Response to Comments Document

Project Description: The request, called the Detroit Permitting Project (DPP), is to allow Marathon to operate at its physical capacity; add air pollution limits at Marathon and Air Products; implement voluntary pollution control projects at Marathon; and increase the height of the vapor recovery unit stack at MPLX.

- Marathon Petroleum Company LP (Marathon),
1001 South Oakwood Blvd, Detroit, Michigan
[APP-2024-0053](#)
Permit to Install (PTI) No. [94-24](#)
- Air Products and Chemicals, Inc. (Air Products)
1025 South Oakwood Blvd, Detroit
Michigan [APP-2024-0055](#)
PTI No. [95-24](#)
- MPLX Terminals LLC – Detroit LP Terminal (MPLX)
12700 Toronto Street, Detroit, Michigan
[APP-2024-0054](#)
PTI No. [52-15A](#)

Figure 2 AQD Gasoline modeling using a 2 mg/L VRU emission rate and 20 foot VRU stack.

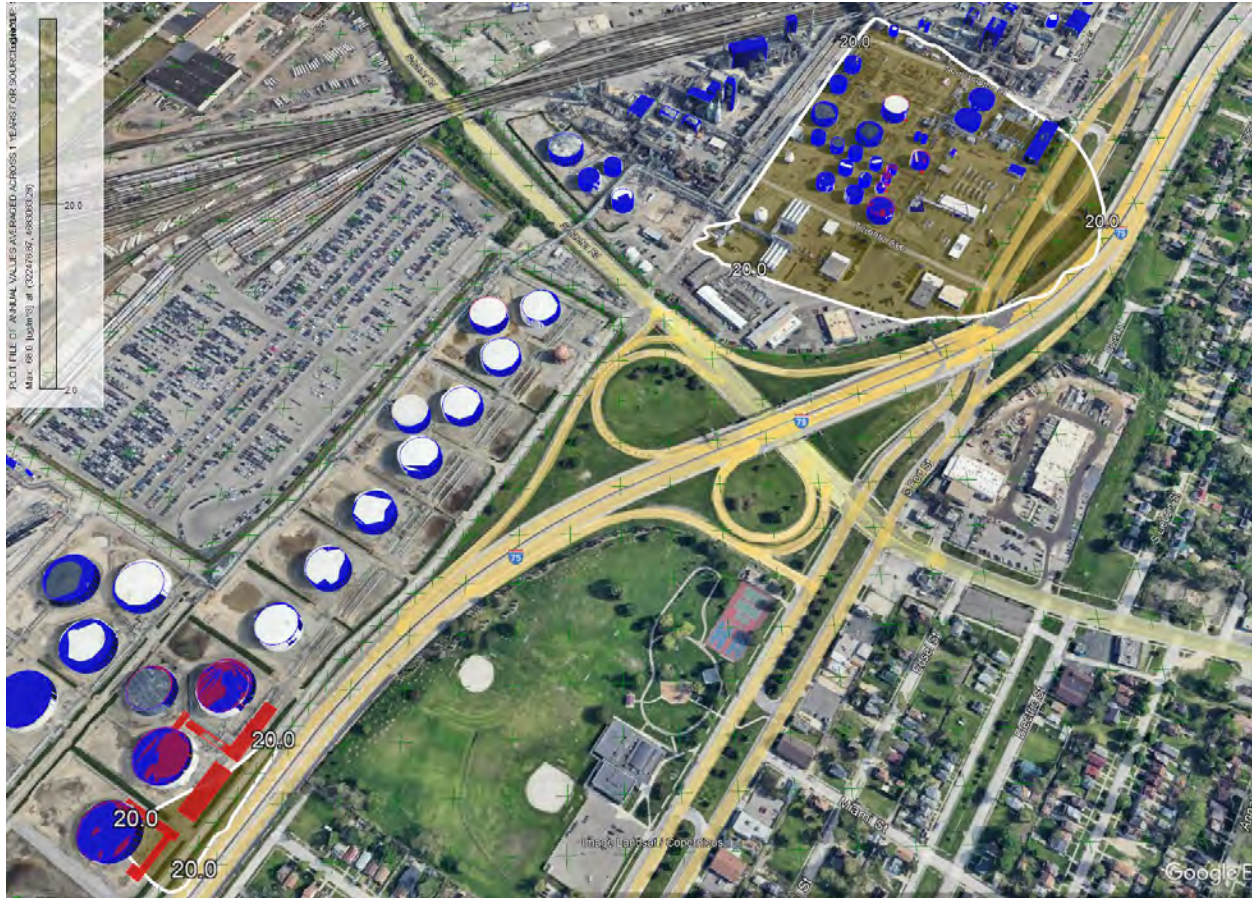
Increasing the height of the MPLX VRU stack does not reduce pollution, it just spreads it around.

The commenter is correct that increasing the stack height does not reduce the amount of emissions coming from the VRU. The VRU stack height was increased to reduce the allowed ground-level gasoline concentration that people could be exposed to to comply with AQD Rule 225. Because the allowed concentration of gasoline emissions from the refinery complies with Rule 225, no reduction in VRU emissions is required. Figure 3 in the [technical fact sheet](#) shows the gasoline modeling results, based on the VRU permit limit of 7.5 milligrams (mg) of VOC per liter (L) of gasoline loaded and the taller VRU stack, comply with Rule 225.

As mentioned during the [informational meeting](#) on May 22, 2024, the AQD also used a VRU emission rate of 2 mg/L and the shorter stack to estimate a more realistic ground-level gasoline concentration. Based on emission testing, the actual VRU emission rate is about 1 mg/L. As shown in Figure 2, the gasoline concentration from this scenario is less than the secondary risk screening level in all areas that are not public roadways or industrial property. This indicates people have not been exposed to actual gasoline concentrations from the facility that would exceed the Rule 225 health-based screening level.
